**DEPARTMENT OF TRANSPORTATION**

**Federal Aviation Administration**

**14 CFR Part 36**

**Noise Certification Standards for Propeller-Driven Small Airplanes**

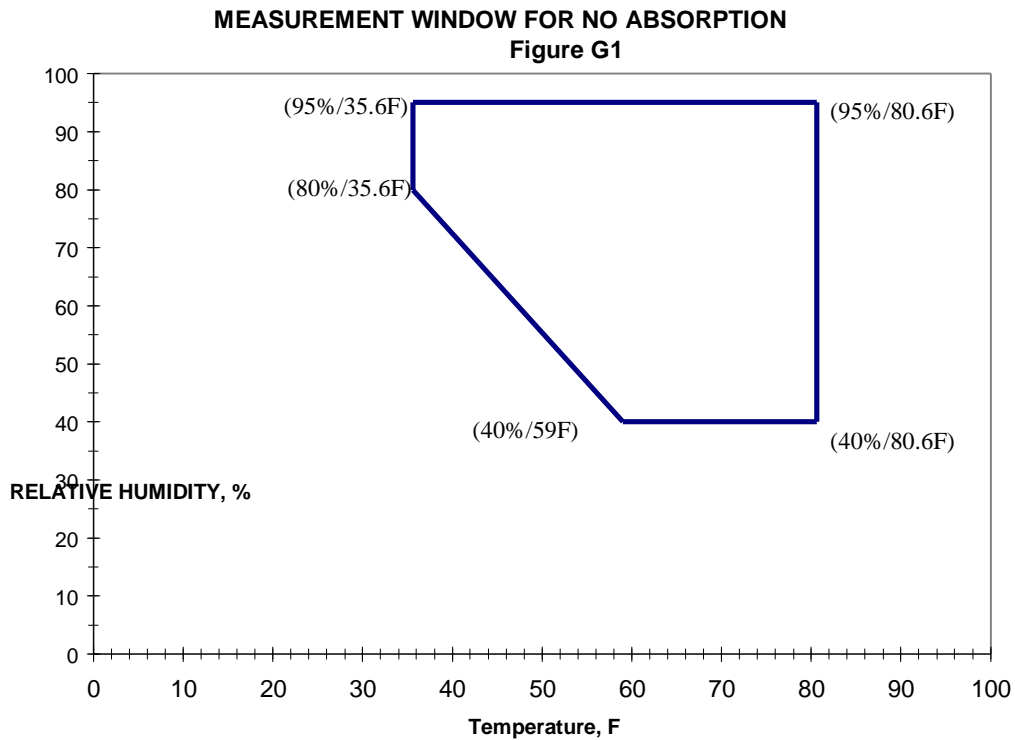
2. Appendix G of part 36 is amended by revising sections G36.107(a), G36.201(b), including Figure G1, G36.201(c), G36.201(d)(1), G36.201(d)(4), and G36.301(b), including Figure G2, to read as follows:

(b) Atmospheric absorption correction is required for noise data obtained when the test conditions are outside those specified in Figure G1. Noise data outside the applicable range must be corrected to 59 F and 70 percent relative humidity by an FAA approved method.

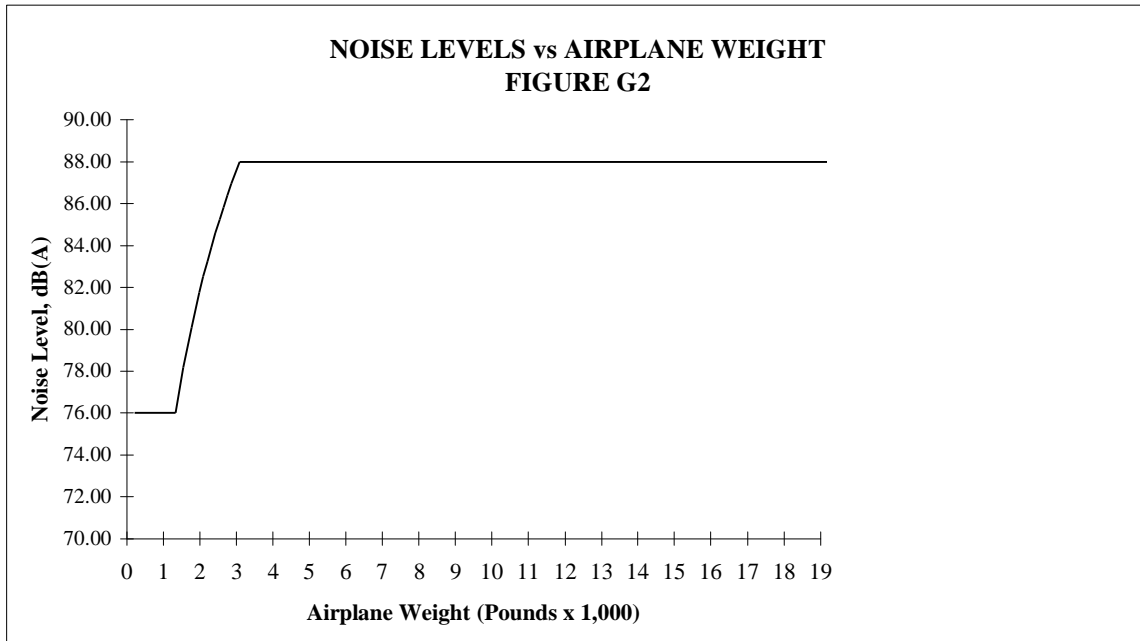
(b) The noise level must not exceed 76 dB(A) up to and including aircraft weights of 1,320 pounds (600 kg). For aircraft weights greater than 1,320 pounds, the limit increases from that point with the logarithm of airplane weight at the rate of 9.83 dB (A) per doubling of weight, until the limit of 88 dB (A) is reached, after which the limit is constant up to and including 19,000 pounds (8,618 kg). Figure G2 shows noise level limits vs airplane weight.
